**ADDENDUM NUMBER 3:**

Re: Renovations to Brownsville Community Resource Center  
Specification Number: PD 15-16.060

Attachments: Fire Protection drawing FP1, dated 6.17.2016.

Project  
**Brownsville Community Resource Center**  
Pensacola, Florida  
Date: 05-16-16  
Project No. 0915  
Sheet No. **FP1**

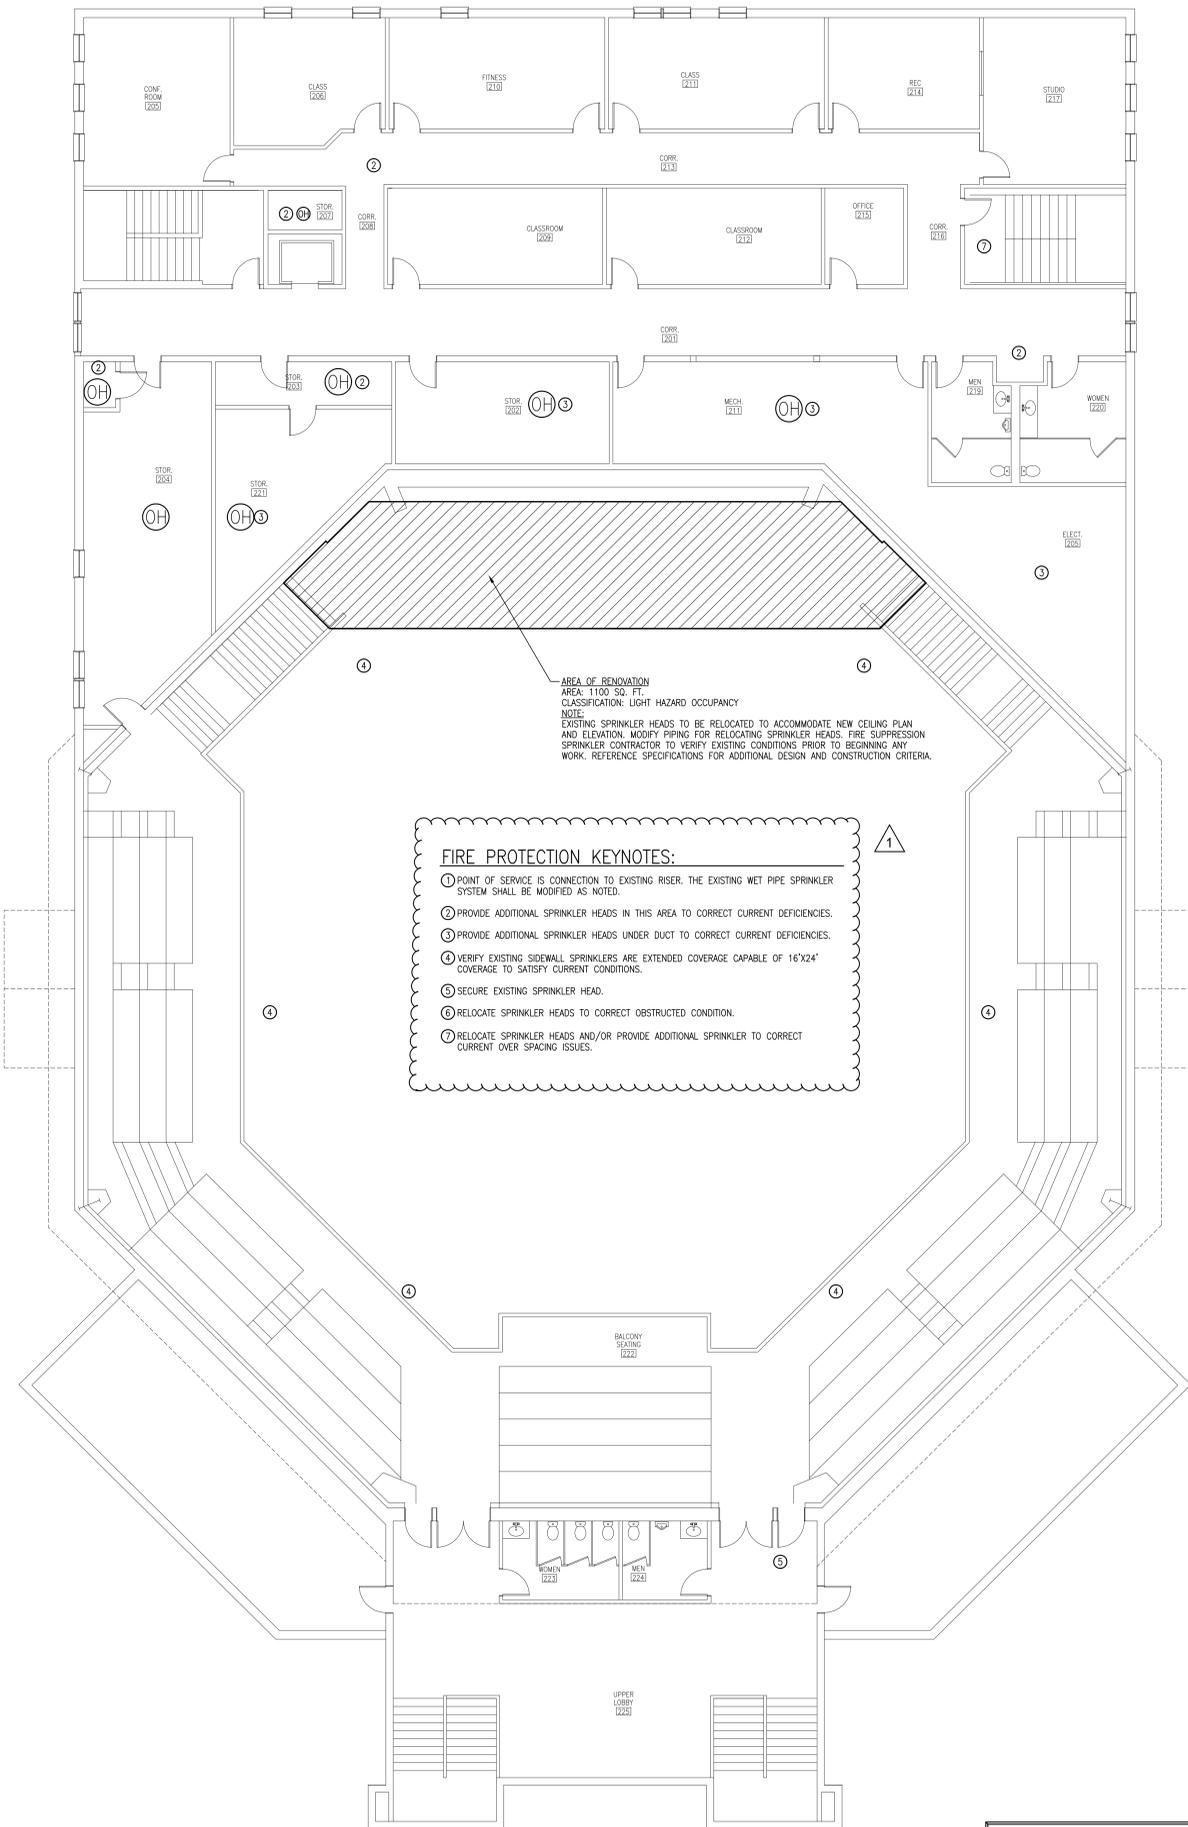
2. Clarification: Referenced attached fire protection plan labeled as FP1. This sheet shall be substituted for the original FP1 sheet. Additional areas of service have been identified as needing corrective measures for having a code compliant fire protection sprinkler system. Fire protection general notes and key notes have been added to the sheet.

- POINT OF SERVICE IS CONNECTION TO EXISTING RISER. THE EXISTING WET PIPE SPRINKLER SYSTEM SHALL BE MODIFIED AS NOTED.
- PROVIDE ADDITIONAL SPRINKLER HEADS IN THIS AREA TO CORRECT CURRENT DEFICIENCIES.
- PROVIDE ADDITIONAL SPRINKLER HEADS UNDER DUCT TO CORRECT CURRENT DEFICIENCIES.
- VERIFY EXISTING SIDEWALL SPRINKLERS ARE EXTENDED COVERAGE CAPABLE OF 16'X24' COVERAGE TO SATISFY CURRENT CONDITIONS.
- SECURE EXISTING SPRINKLER HEAD.
- RELOCATE SPRINKLER HEADS TO CORRECT OBSTRUCTED CONDITION.
- RELOCATE SPRINKLER HEADS AND/OR PROVIDE ADDITIONAL SPRINKLER TO CORRECT CURRENT OVER SPACING ISSUES.
